Access Compliance Report

Public Rights-of-Way

Intersection ID: 52765	Main Street: SHOPTON_RD	Cross Street: OUTLETS_BV	Location: SW
ADA ID: 3C35F42E63E0	Ramp Type: PerpDiag	Initial Pass/Fail: Fail	Overall Compliance: No
		Severity Score: 37.5

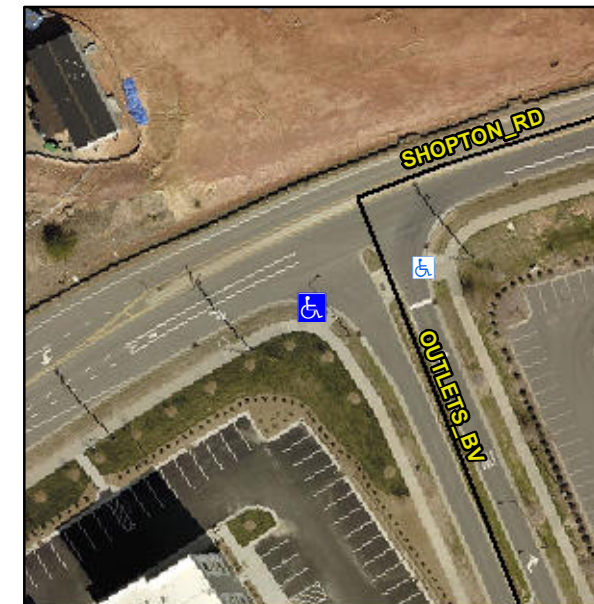
Not Found, R304.2.2, R304.5.3

Compliance	Description	Data	Compliance	Description	Data
N/A	Ramp Length (in)	94.0	No	Ramp Slope (%)	8.5
Yes	Ramp Width (in)	48.0	No	Ramp XSlope (%)	8.3
N/A	Flare Type LT	N/A	N/A	Flare Type RT	N/A
N/A	Flare Slope LT (%)	N/A	N/A	Flare Slope RT (%)	N/A
N/A	Flare Traversable LT?	N/A	N/A	Flare Traversable RT?	N/A
N/A	Landing Length (in)	N/A	N/A	DWS Provided?	N/A
N/A	Landing Width (in)	N/A	N/A	DWS Contrast?	N/A
N/A	Landing Slope (%)	N/A	N/A	DWS Length (in)	N/A
N/A	Landing X Slope (%)	N/A	N/A	DWS Full Width?	N/A
N/A	Landing Curb? (Y/N)	N/A	N/A	DWS Offset (in)	N/A
N/A	Shared Landing?	N/A			
N/A	Gutter Ponding?	N/A	N/A	Gutter Slope (%)	N/A
N/A	Gutter Lip Ht (in)	N/A	N/A	Gutter X Slope (%)	N/A
N/A	Painted X Walk1?	No	N/A	Painted X Walk2?	No
	X Walk 1 Direction	To N		X Walk 2 Direction	To E
N/A	X Walk 1 Width (in)	N/A	N/A	X Walk 2 Width (in)	N/A
	X Walk 1 Slope (%)	3.5		X Walk 2 Slope (%)	4.0
	X Walk 1 X Slope (%)	0.9		X Walk 2 X Slope (%)	5.6

Remove & Replace Curb Ramp With Two New Directional Ramps or Equivalent.
